**PLANNING, ZONING, & BUILDING DEPARTMENT**  
**PZ&B Staff Memorandum**

**SUBJECT:** ZON-23-036 (ARC-23-019) 247 SEASPRAY AVE (COMBO)

**ZON-23-036 (ARC-23-019) 247 SEASPRAY AVE (COMBO)—VARIANCES.** The applicant, Alicia Grace (ALICIA GRACE TR TITL HLDR), has filed an application requesting Town Council review and approval for (5) variances required to construct a second floor addition on an existing detached single story accessory structure, including variances (1-2) to vest existing non-conforming first story side and rear setbacks due to the demolition of more than 50% of the structure, (3-4) variances to permit the construction of a second story with reduced side and rear setbacks, and (5) to construct a two-story accessory structure within the R-B zoning district on a parcel under 20,000 SF. The Architectural Commission will perform design review component of the project.

**ARC-23-019 (ZON-23-036) 247 SEASPRAY AVE (COMBO).** The applicant, Alicia Grace (ALICIA GRACE TR TITL HLDR), has filed an application requesting Architectural Commission review and approval for the construction of a second floor addition on an existing single-story detached accessory structure, requiring

The variance requests to vest existing ground floor non-conformities are illustrated in red in the graphic below (miniset Sheet EL-VA).

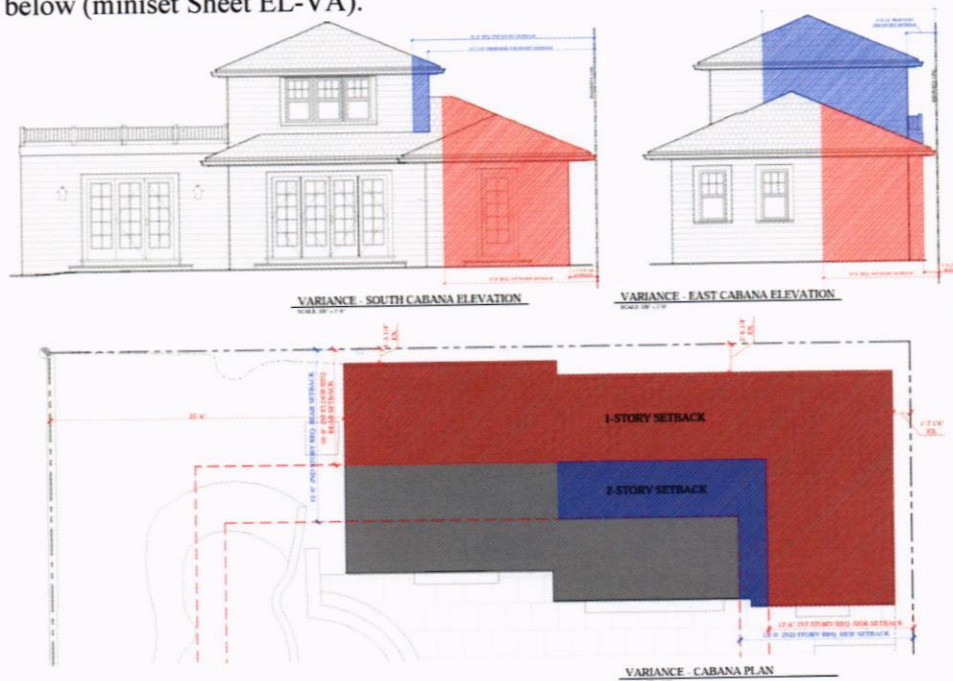
A preliminary review of the project indicates that the application, as proposed, is inconsistent with the Town zoning code and requires five variances for the construction of a second floor on an existing non-conforming rear accessory structure.

The existing single story accessory structure was constructed with rear (north) and side (east) setbacks that do not conform to today's R-B district setback provisions. Although this is a legal non-conforming condition, the current request demolishes more than 50% of the building's roof structure. With the demolition of more than 50% of any façade or roof structure, the Town's zoning code compels the structure to come into full compliance with current zoning regulations. Therefore, the existing non-conforming first floor requires two variances to maintain the existing setbacks. The application does not seek to expand the ground floor of the building and does not further reduce the existing setbacks. The two variance requests are as follows:

The application requests to construct a new second floor addition atop the existing single-story structure. The proposed second floor encroaches into the rear (north) and side (east) second-floor setbacks, requiring two variances. These encroachments are illustrated in blue in the above graphic. Additionally, a parcel within the R-B zoning district must be at least 20,000 SF in area to have a two-story accessory structure, therefore a variance is required due to a substandard parcel area of 9,138.5SF. The applicant has submitted a detailed Letter of Intent outlining the variance criteria and providing hardship justifications for the requests. The three variance requests for the construction of a new non-conforming second floor are as follows:
